SDARS/WCS Rulemaking

Sirius Satellite Radio Inc. & XM Radio Inc.

Technical Presentation to FCC Wireless Bureau

May 9, 2008

Figure 1. WCS Coalition proposed OOB mask for mobile CPE

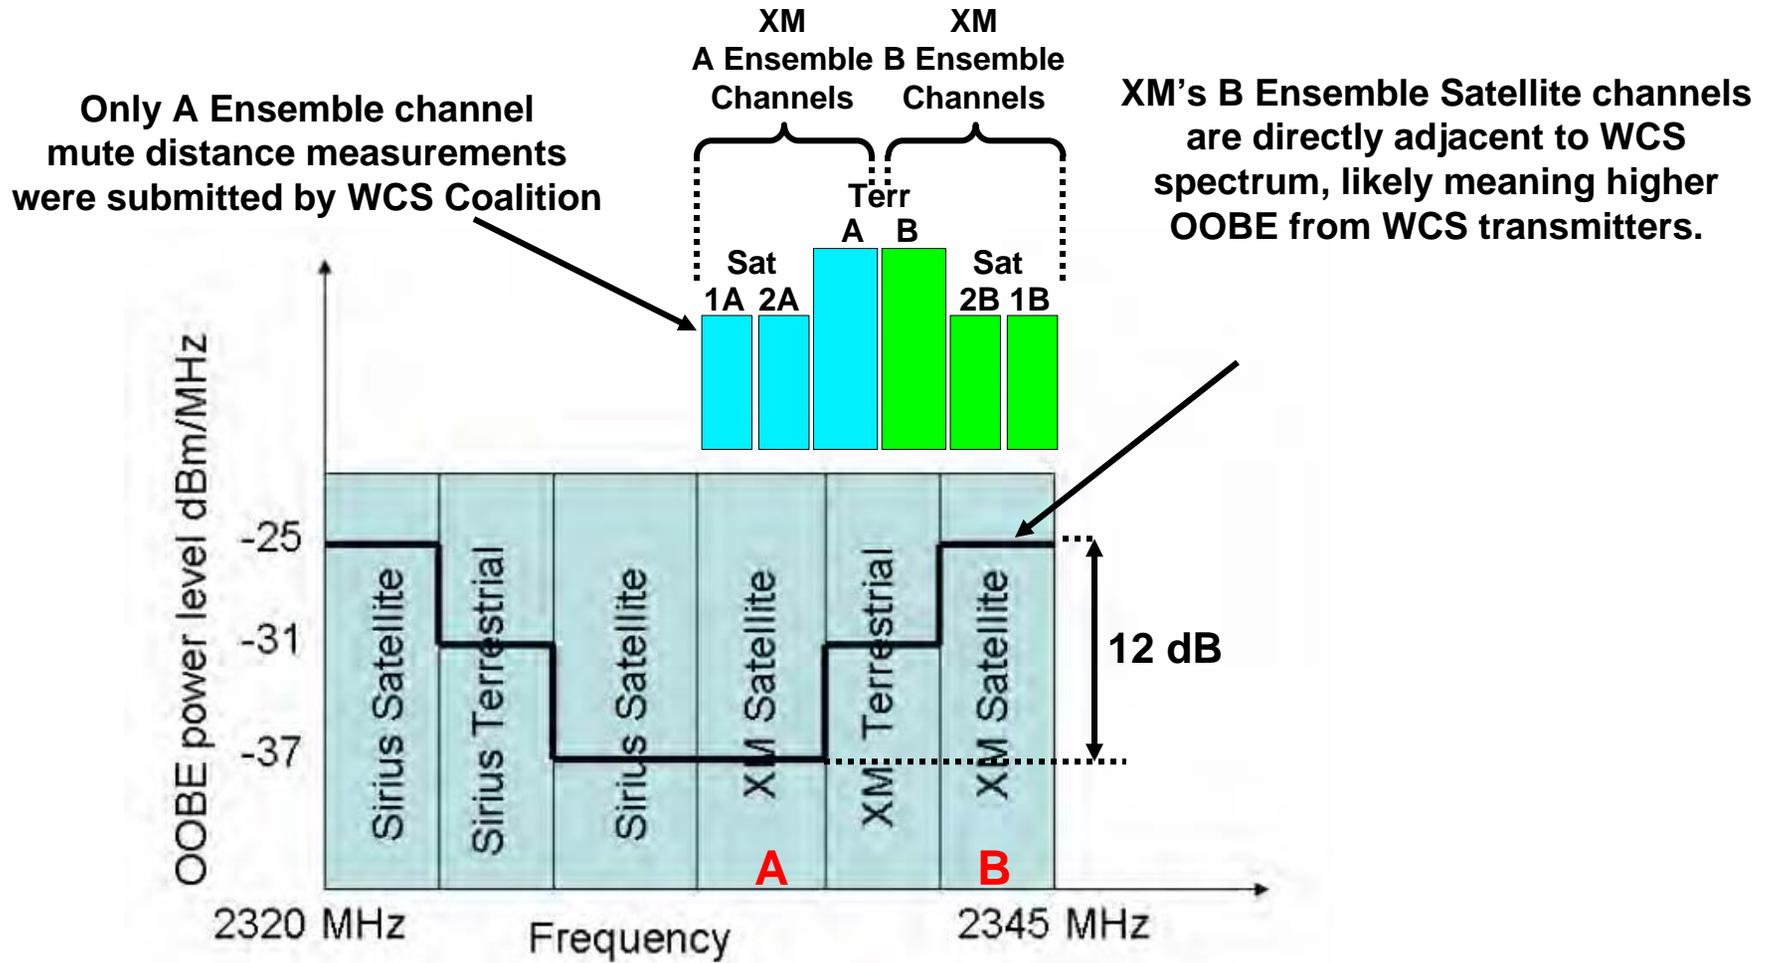
2. OOB Test Methodology Overly Narrow and Fundamentally Flawed

- Never measured interference to XM satellite channels located closest to WCS band (testing limited to “free” channel in Ensemble A)
 - Underestimated interference levels by 12 dB
 - Stepped OOB mask inappropriate, because it sanctions added interference to half of SDARS downlink channels.

In contrast, accurate tests should have a flat OOB mask.
- Best-case interference measurements result in overly-optimistic conclusions
 - Clear line-of-sight to SDARS satellites (no link margin sacrificed for foliage, terrain or other blockage)
 - Stationary receiver (no link margin sacrificed for fading)
 - Best case geographical test locations for strongest satellite signal (strongest possible sat signals for high $S/(I+N)$)
- In contrast, normal, real-world conditions with reduced link budget due to foliage, mobility, location, etc., will expand the WCS-generated muting zones.
